City of Carlisle, Iowa
Planning and Zoning Commission
Regular Meeting
October 16, 2023

RE: PDM Metals Building #2 – Site Plan Review
Project No. 7023.051
City of Carlisle, Iowa (City)

FOX Strand has completed the first review for the PDM Metals Building #2 Site Plan dated October 3, 2023. Please address the following comments:

RE: CTI Ready Mix (2023) – Site Plan Review
Project No. 7023.051
City of Carlisle, Iowa (City)

Sheet C1.1 - Topographic Survey, Demolition Plan and Details

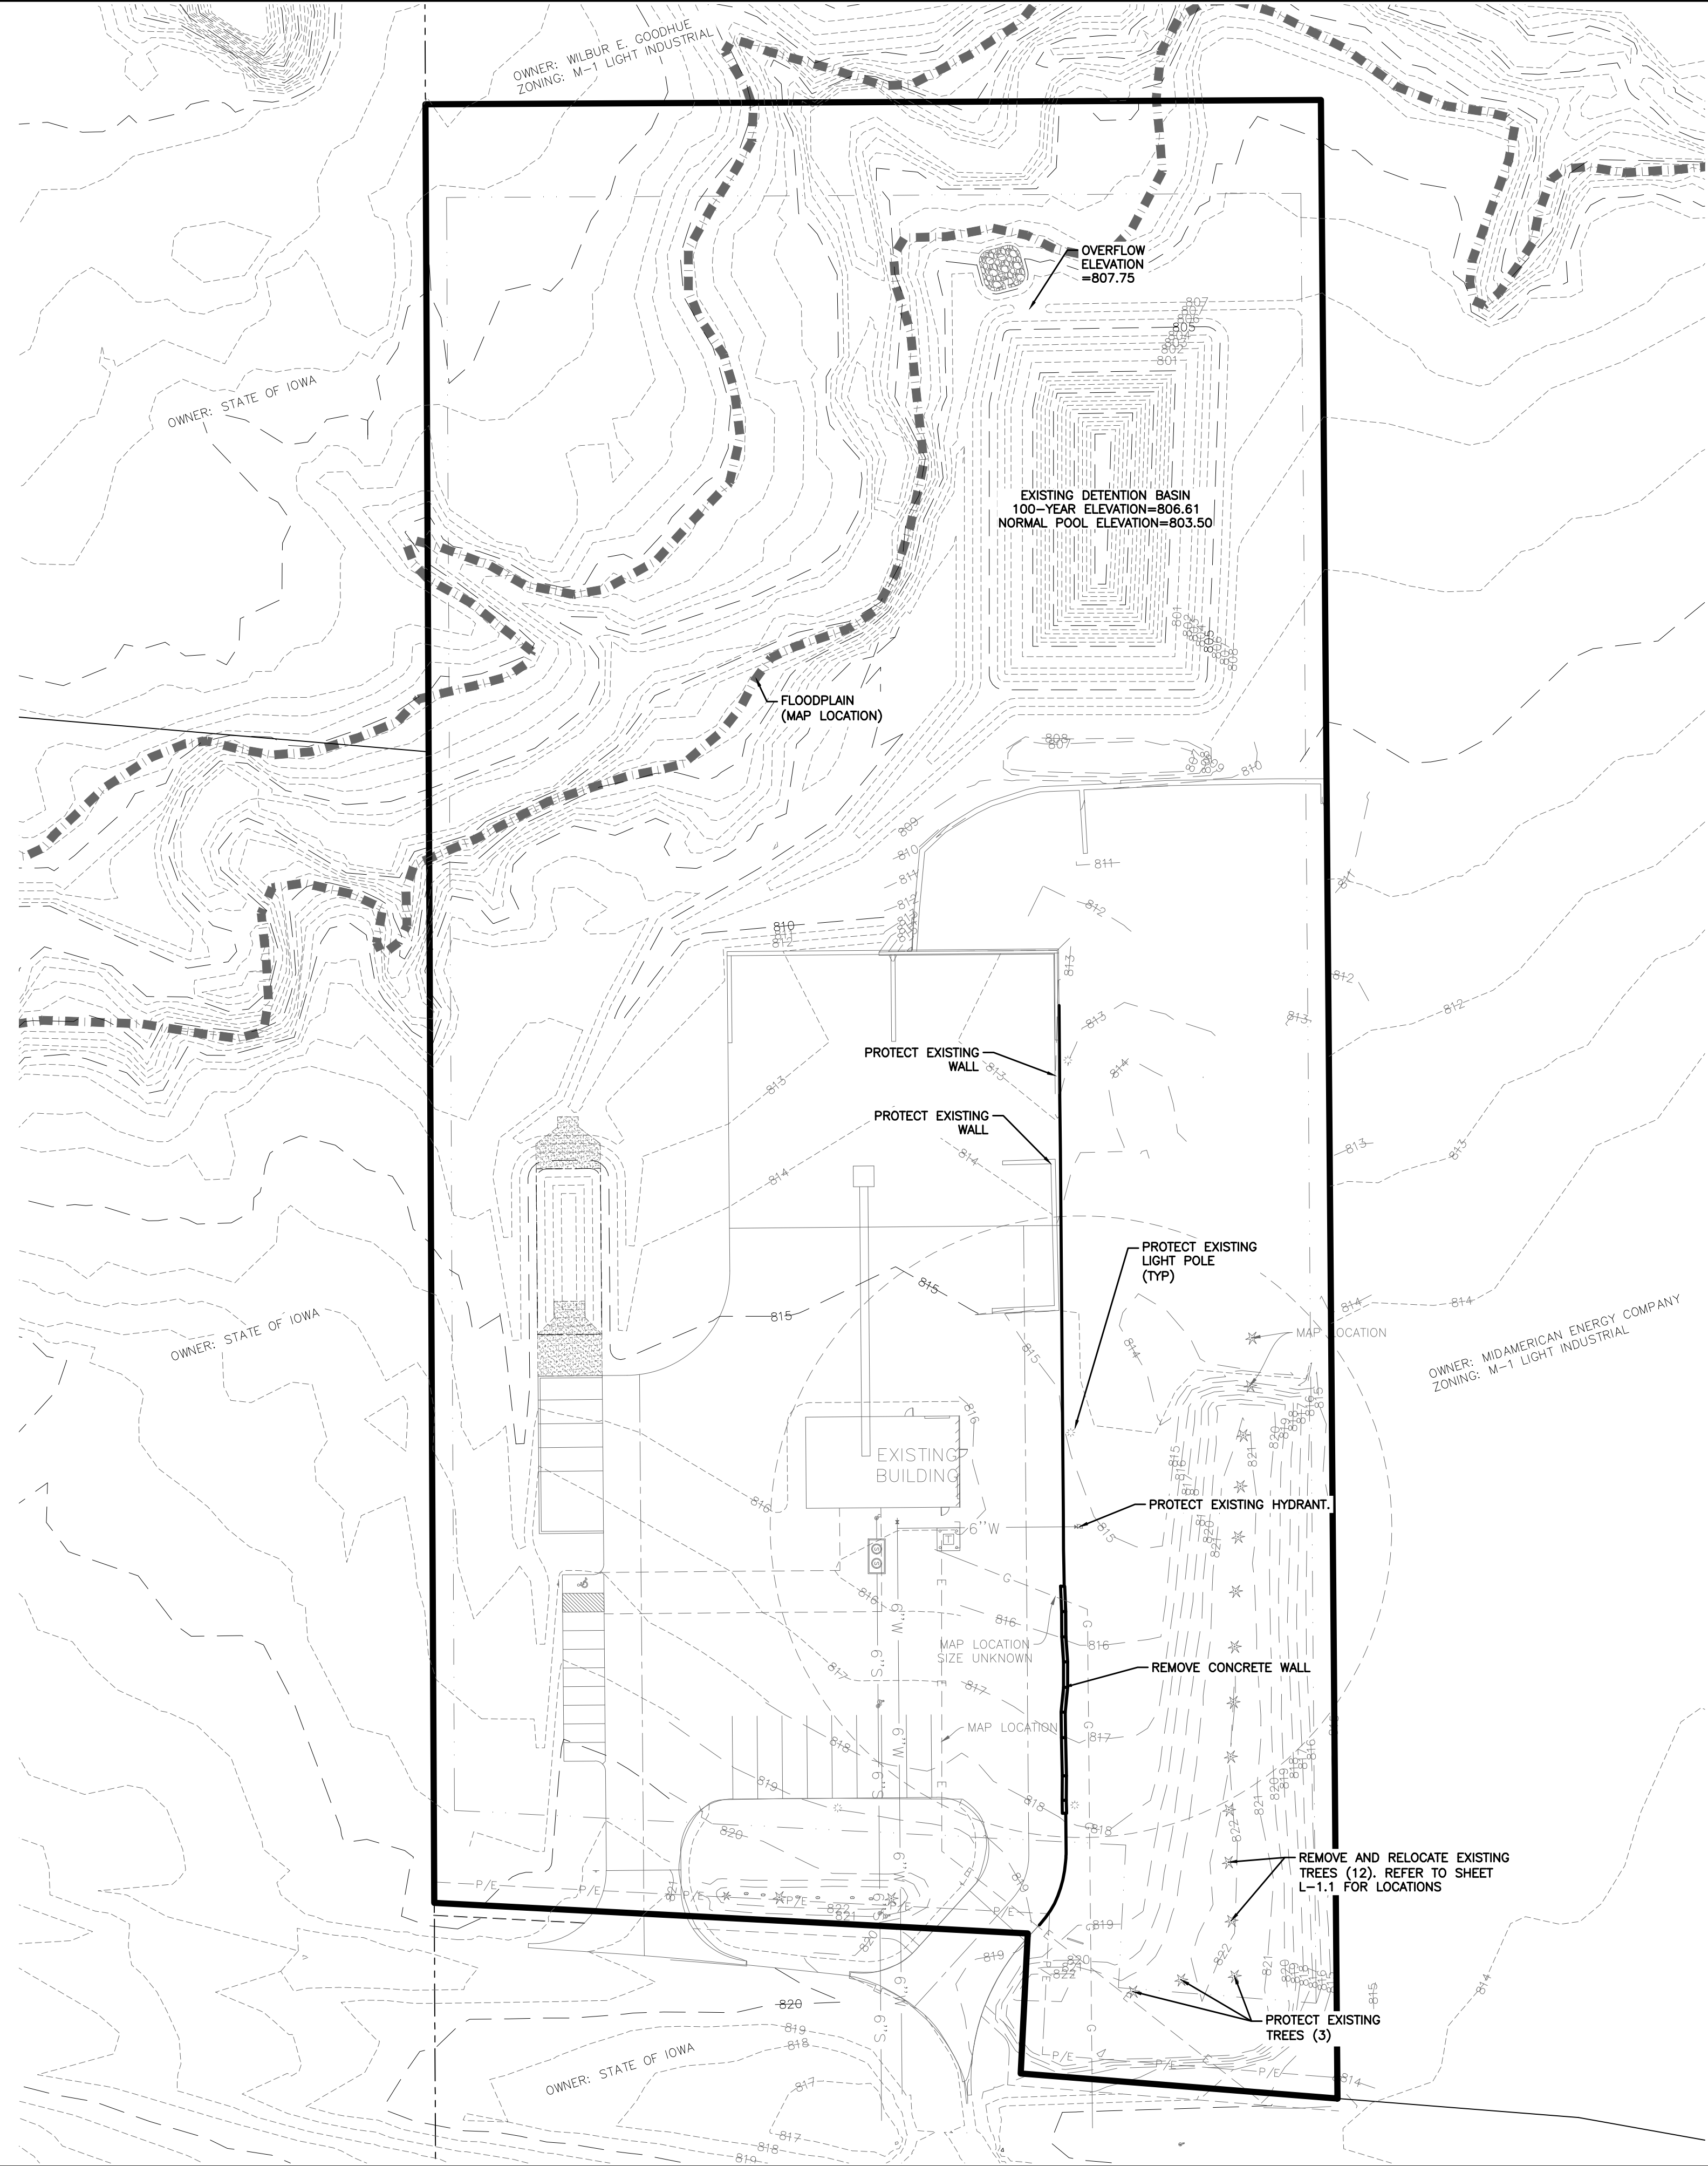
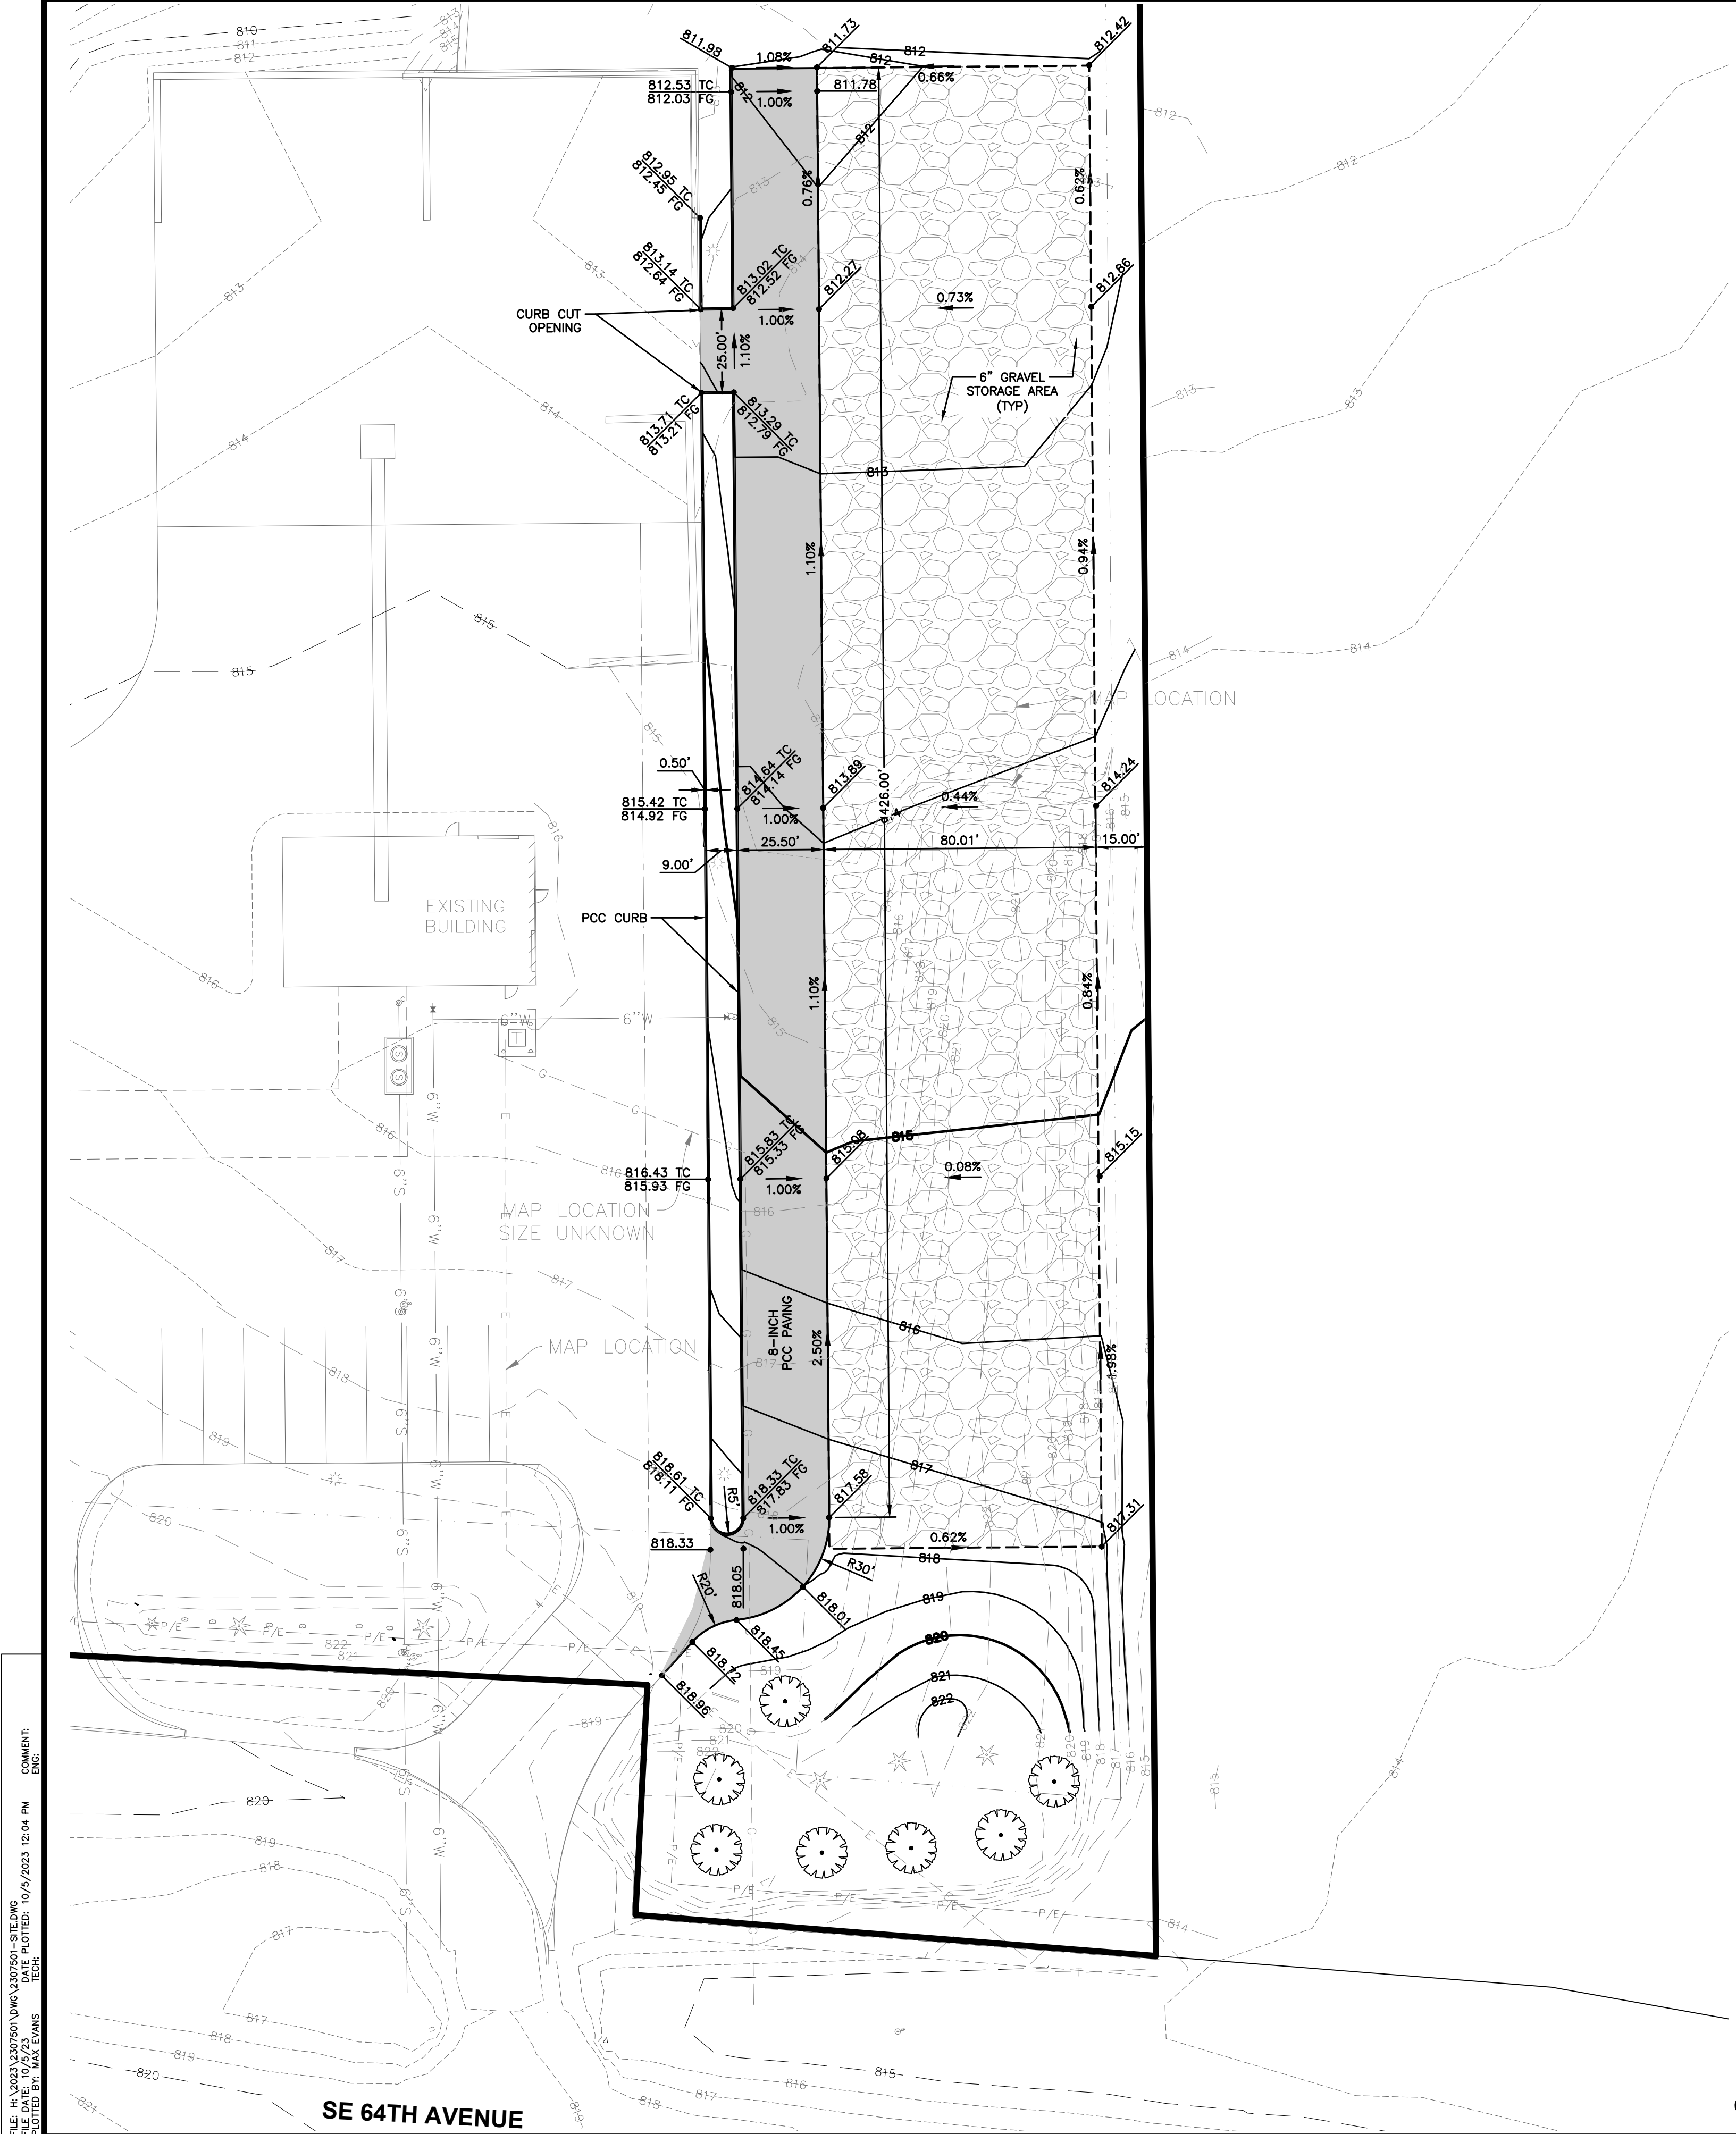
5. There is a wall shown in the NE corner of the site without any labeling. Please provide a label and indicate that this wall is removable and/or temporary as it resides partially in the side yard setback.

Sheet C2.1 - Dimension and Grading Plan

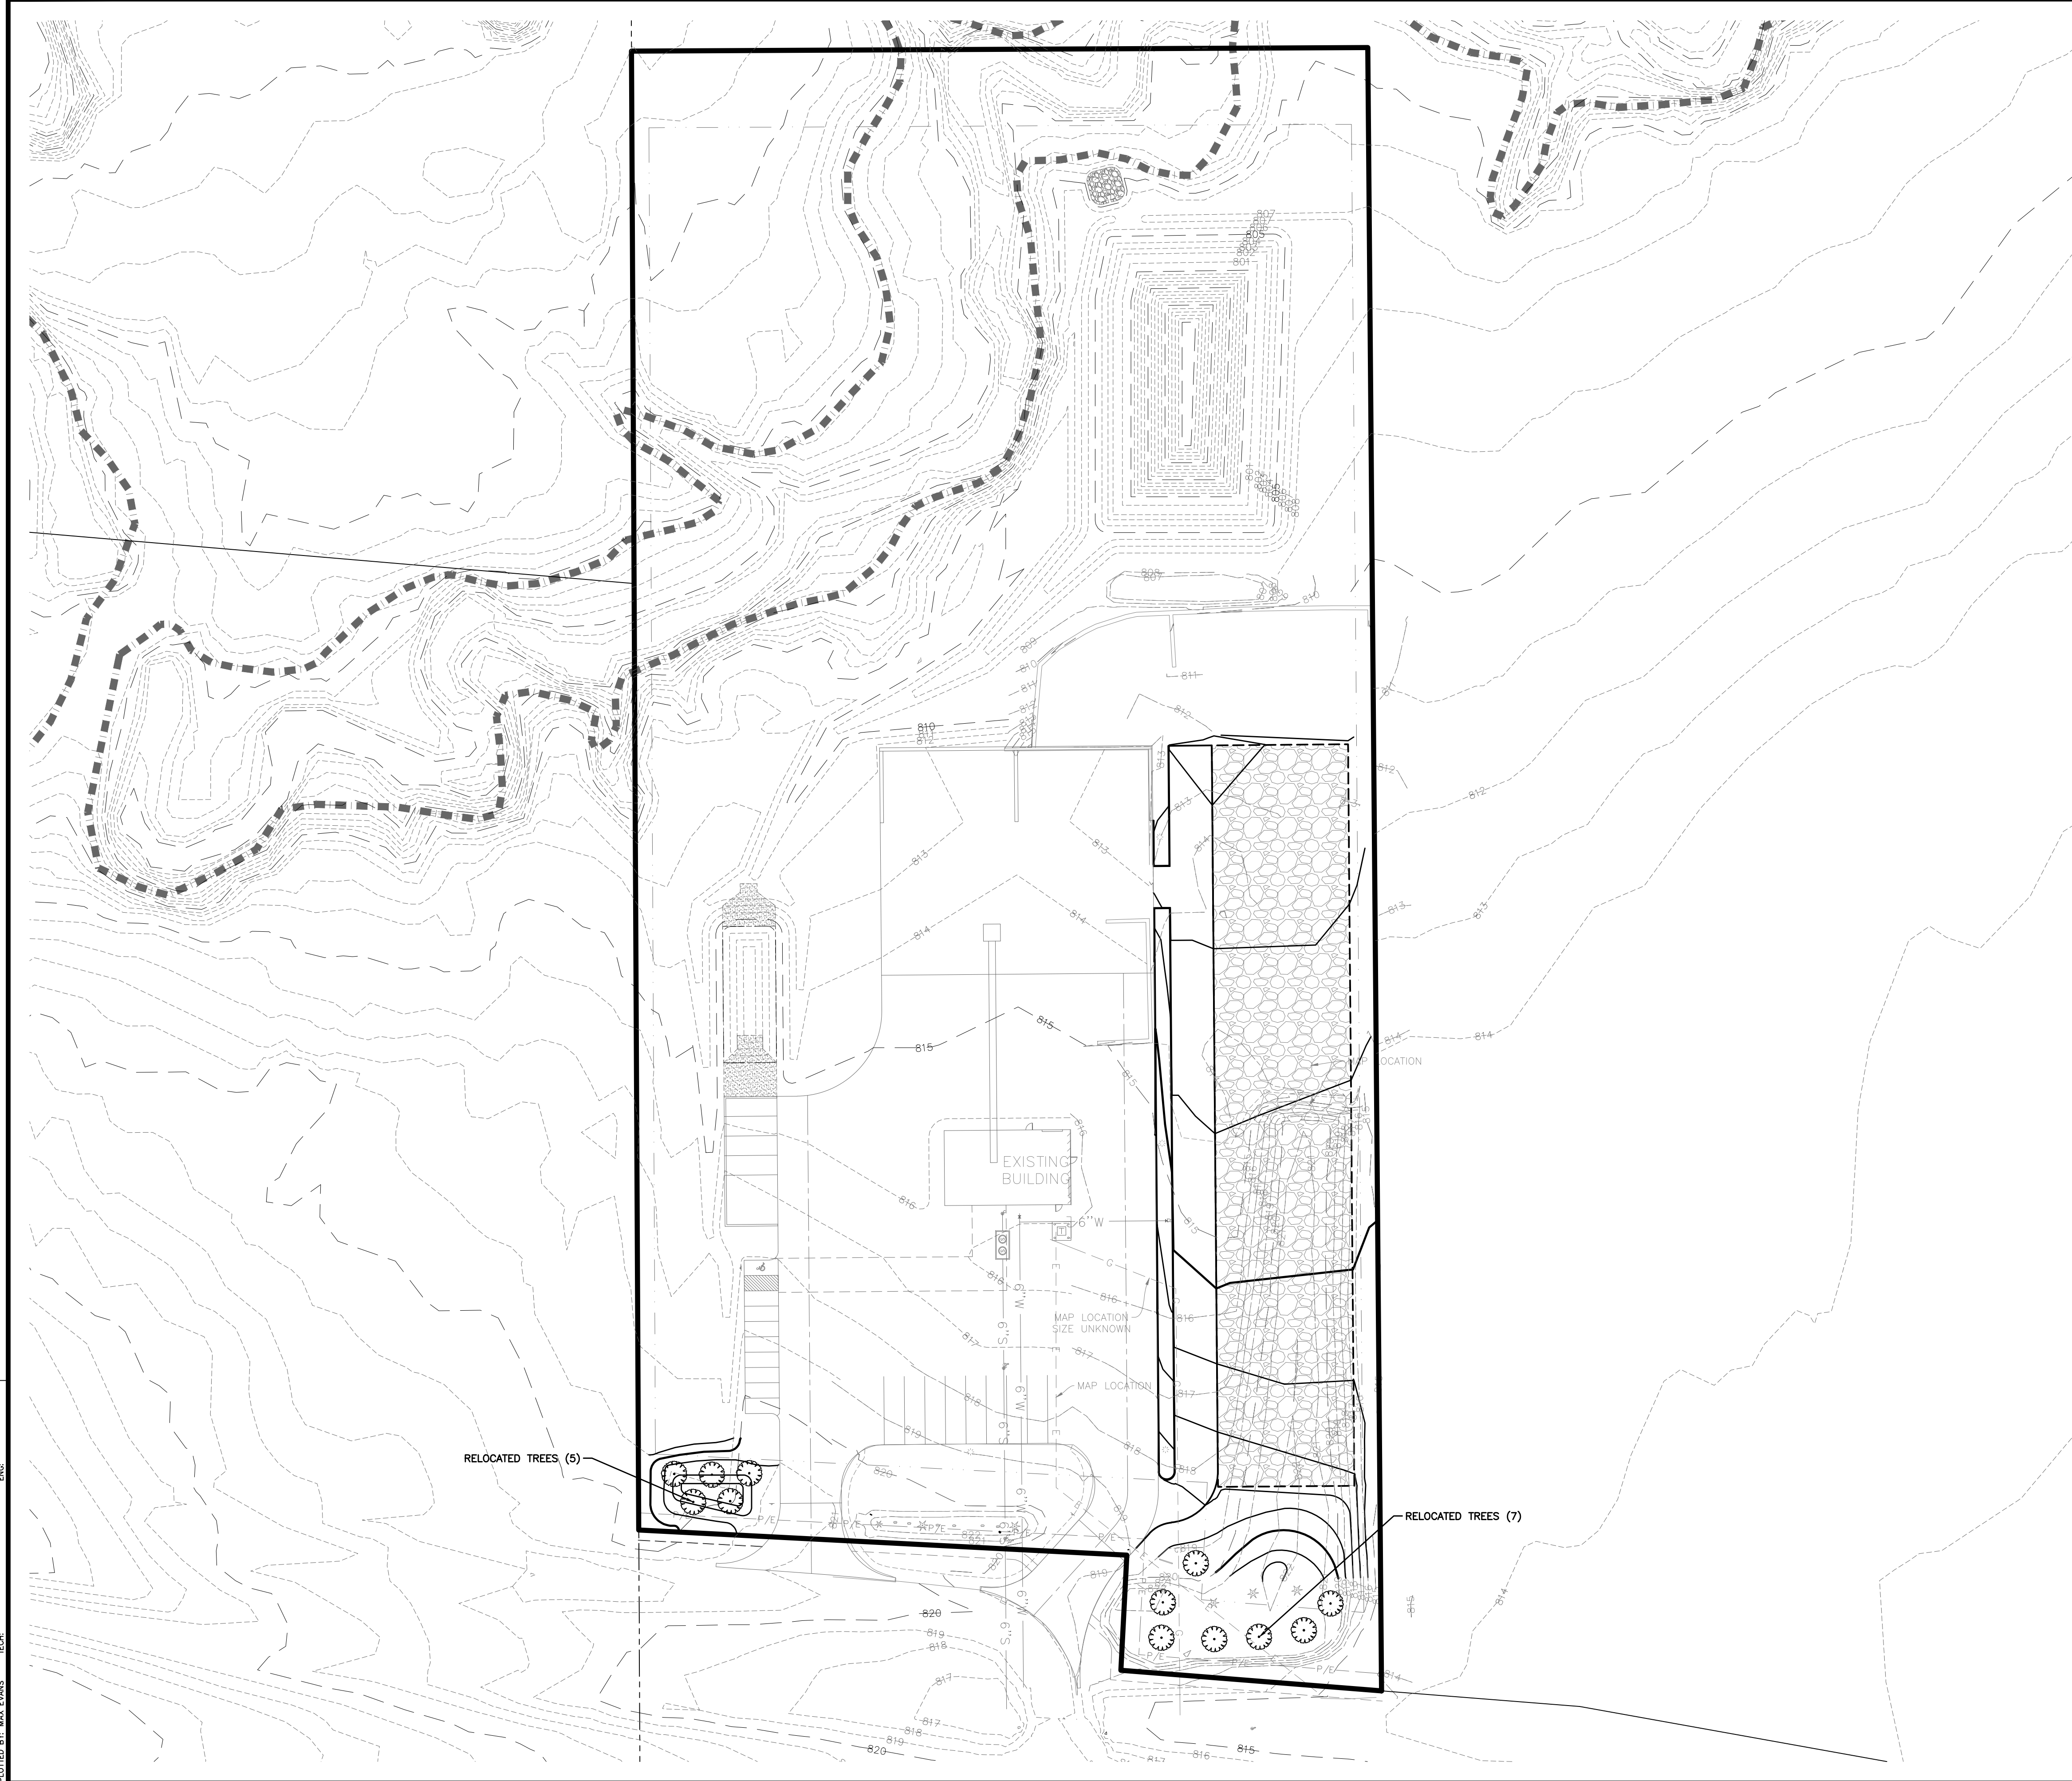
6. Please clarify what the surfacing will be in the median area between the new concrete and existing concrete area. It is our assumption this area is not intended to be grass.
